Summary of Submissions:

NO. 109 (LOT 100) PALMERSTON STREET, PERTH RESPONSE TO SUBMISSION – FOUR (4) GROUPED DWELLINGS

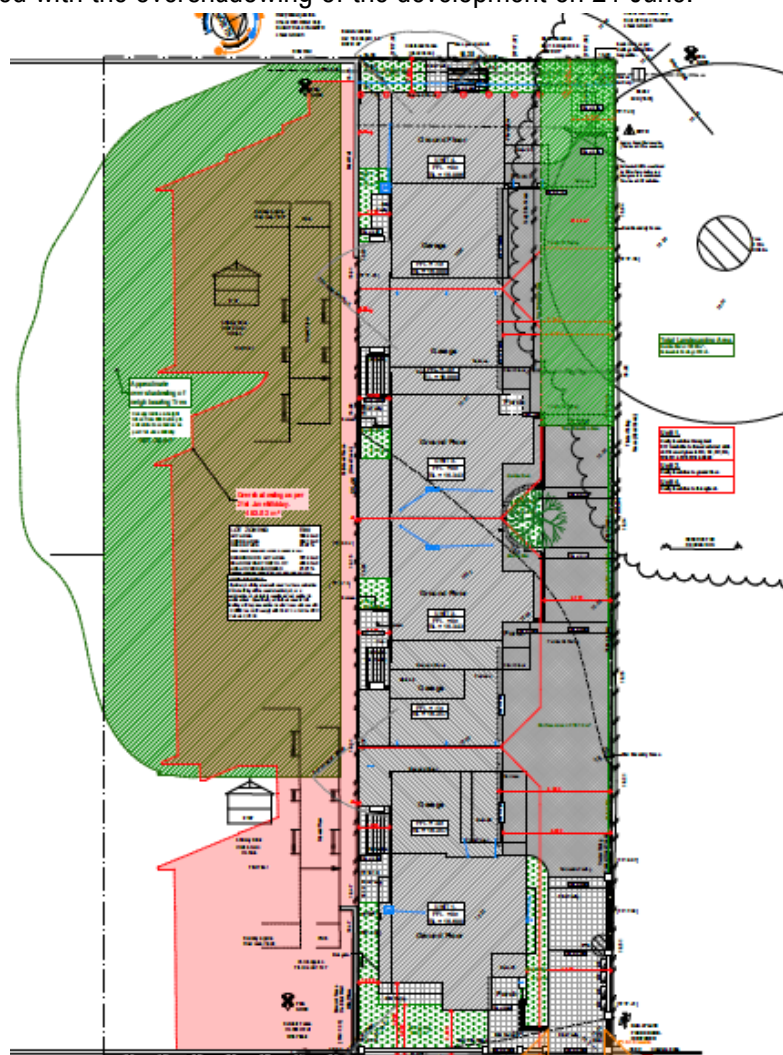
In reviewing our client's development plans, it is considered the assertions made by Planning Solutions, particularly that the proposed development does not meet the performance criteria set out in Clause 5.4.2 (i.e., designed to protect solar access for neighbouring properties), is inappropriate for the following reasons:

- The form of the proposed development is entirely acceptable on the basis that it responds to the constraints that are unique to this property discussed above.
- It is unreasonable and disproportionate to request that the design should “*protect solar access for neighbouring properties*” (Clause 5.4.2 of the R-Codes Vol. 1), when the Fig Tree causes such a significant overshadowing contribution to No. 107 Palmerston Street in its own right – refer to below image taken from the development plans which depicts the overshadowing of the Fig Tree (shaded green) compared with the overshadowing of the development on 21 June.

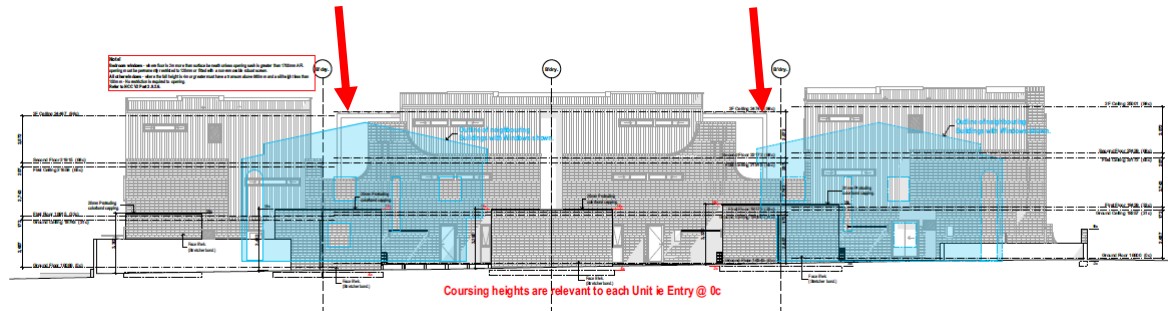
- The proposed design seeks to break-up the built form (as depicted in the development plan elevations) that were inserted to reduce the Outdoor Living Areas adjoining the properties to the south that is overshadowed by the Fig Tree during winter. Additionally, this design feature was requested by the City's Design Review Plan. The below image depicts the location of the spacing/articulation, where light and natural ventilation can be provided to the units to the south.

- The overall design also seeks to break-up the proposed built form through the use of meaningful articulations and spacing between the dwellings. This allows northern sunlight to filter through to the properties to the south at No. 107 Palmerston Street, particularly as it is clear that sunlight will be able to pass through to some of the major openings associated with the buildings to the south.
